CITY PLAN COMMISSION STAFF REPORT

CD-CPC-2026-00023

5019 Raytown Road

Plan Conditions, Corrections, & Suggestions Report

PROFESSIONAL SEAL
C103
 ISSUE DATE: 23 FEBRUARY 2026
 COLLINS WEBB # 28029
GRADING PLAN

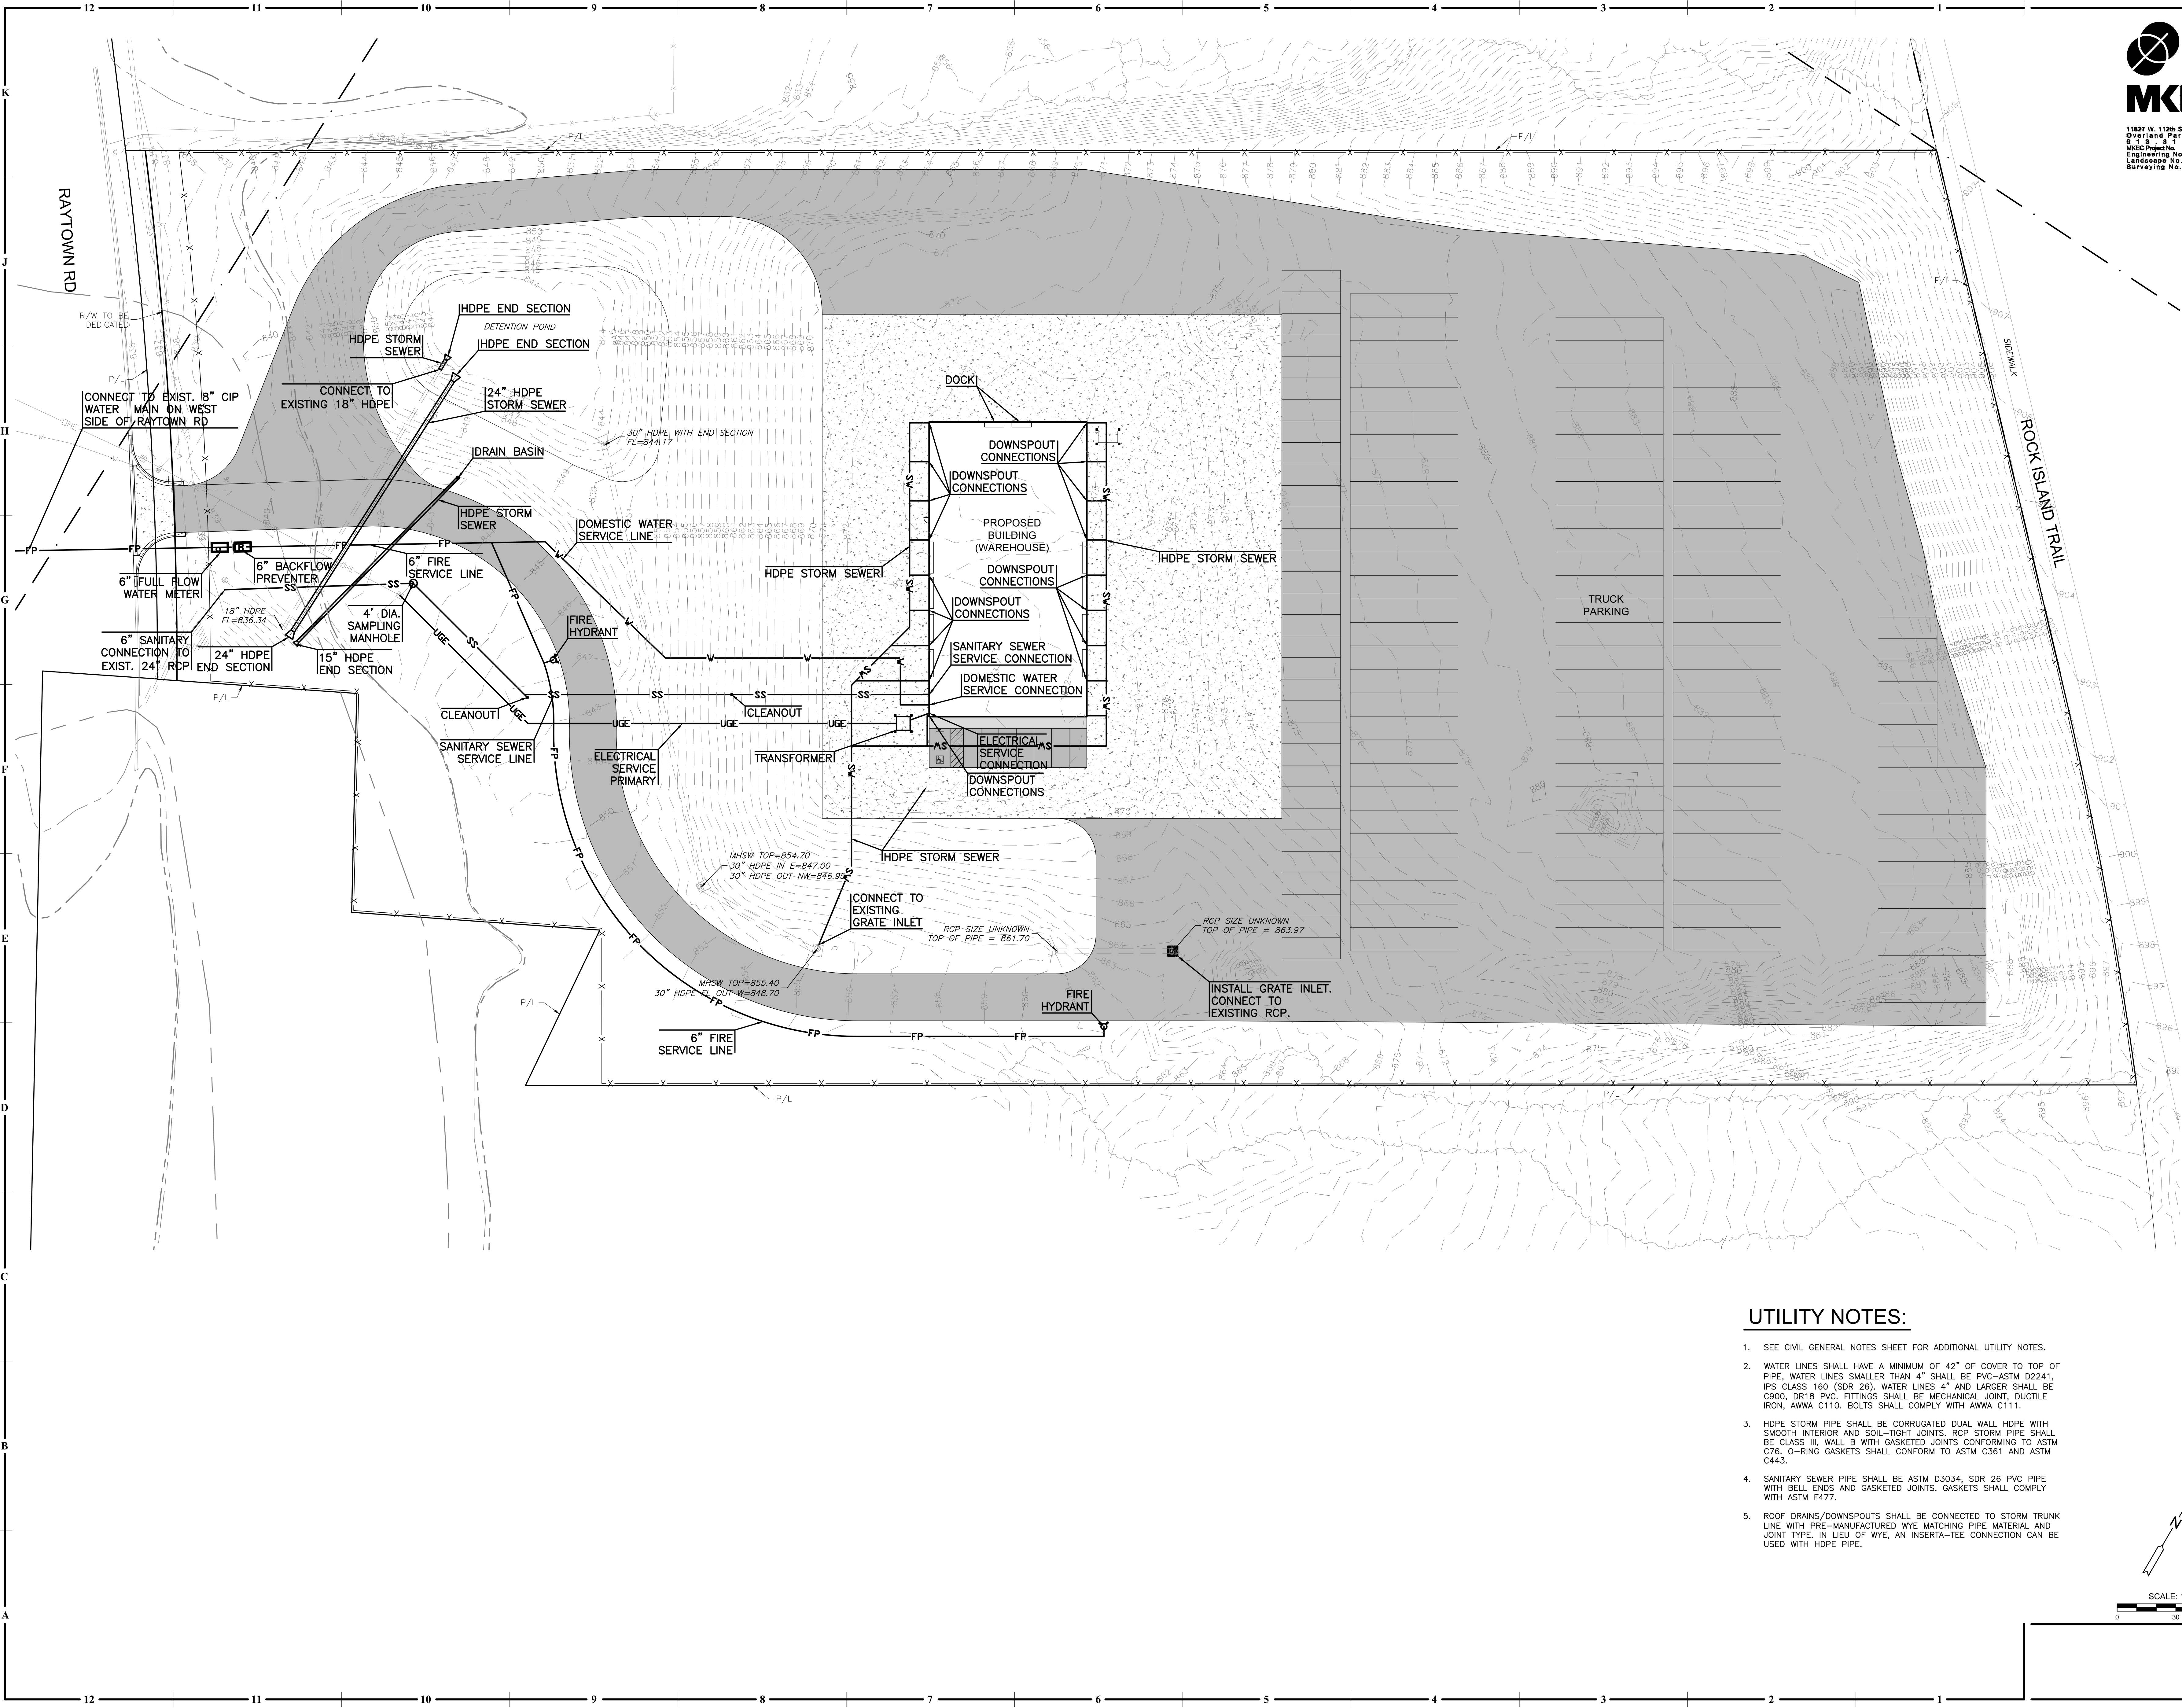
1. Any area of a site not intended for a specific use, must be landscaped unless retained in its natural state. The west side of the southern driveway does not seem paved or vegetated. UPDATED 4-2-26: Plans do not reflect what was discussed in Applicant DRC. (4/10/2026)

UTILITY PLAN

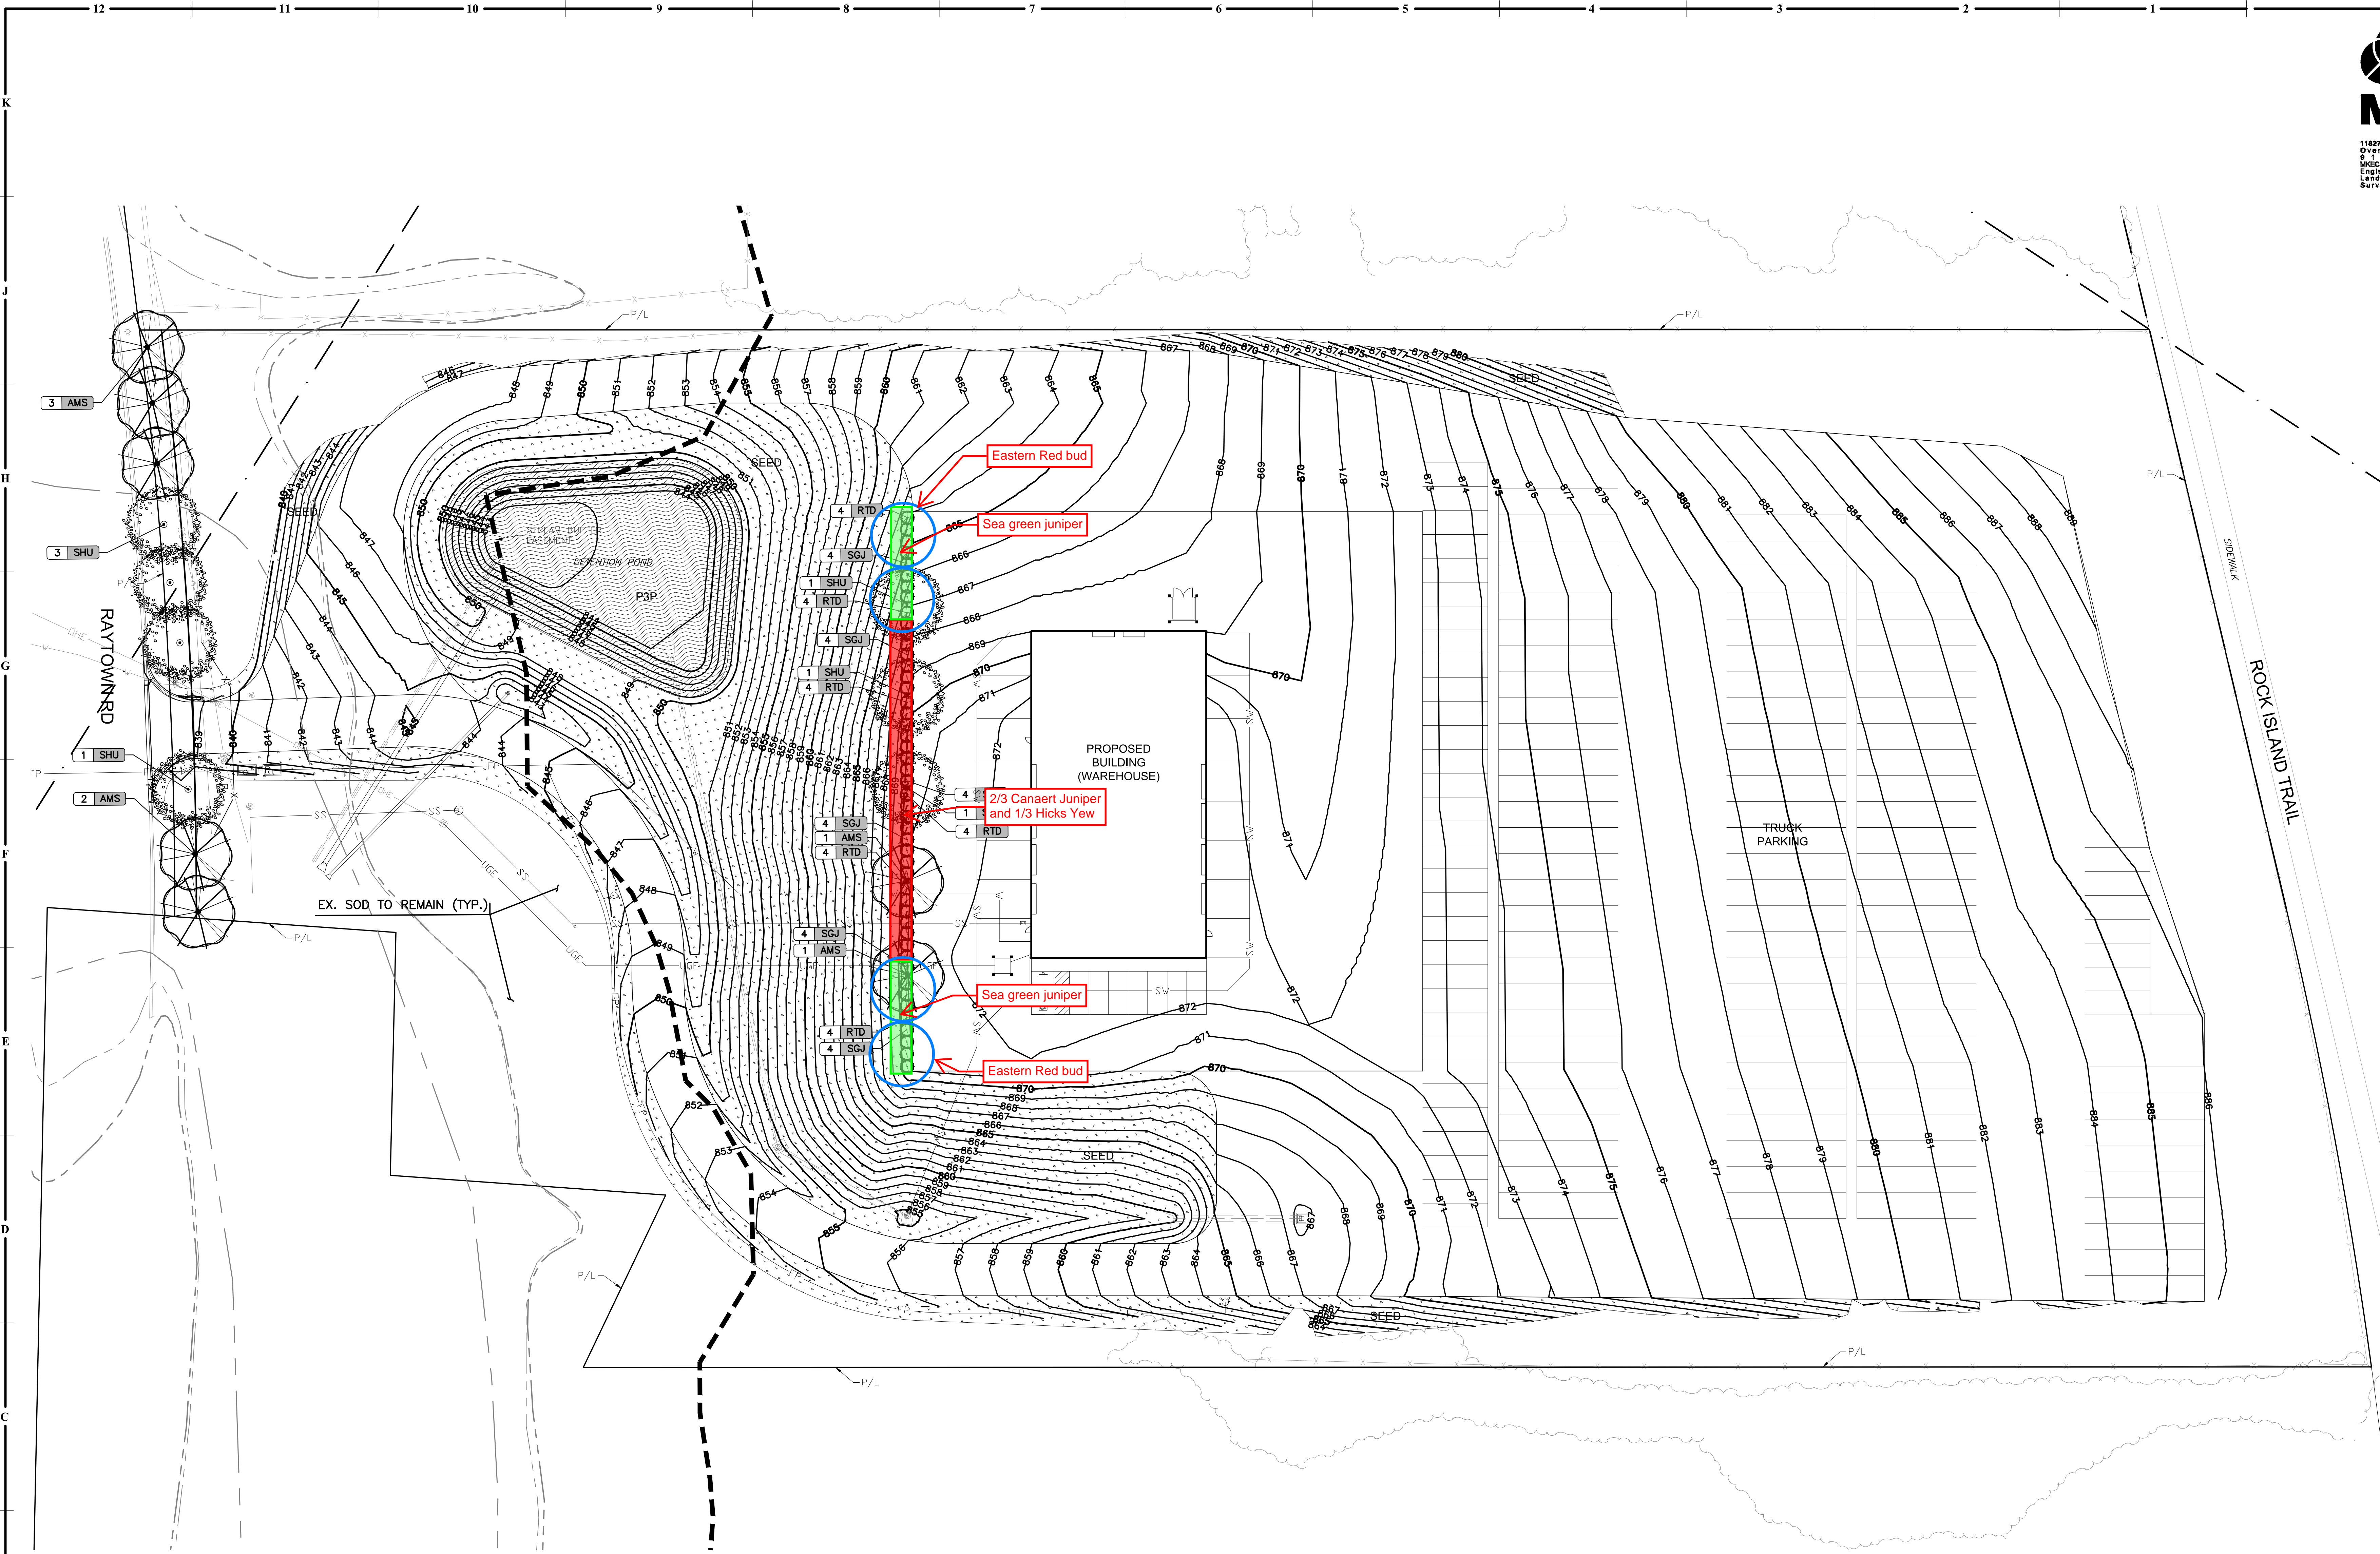
5. Sanitary sewer along Raytown Rd is not a Force main. Call out as 24" RCP interceptor. Manhole connection may require lining (brick manhole). Verify in field if this is an un-lined or lined brick manhole. (4/10/2026)
6. Show both the 24" and 8" public gravity sanitary sewer lines on the utility plan (4/10/2026)
7. show the existing stream buffer easement. (4/10/2026)

8. Show and label a new public Fire Hydrant along Raytown Road on the utility plan sheet to meet the required 300' spacing in commercial zones. (4/10/2026)

44. Developer shall submit water main extension plans in CompassKC meeting KC Water Rules and Regulations for a new public fire hydrant along Raytown Road to meet the 300' max. spacing requirement. The plans shall be prepared by a Missouri PE and shall be under contract (permit) prior to building permit issuance. (3/04/2026)
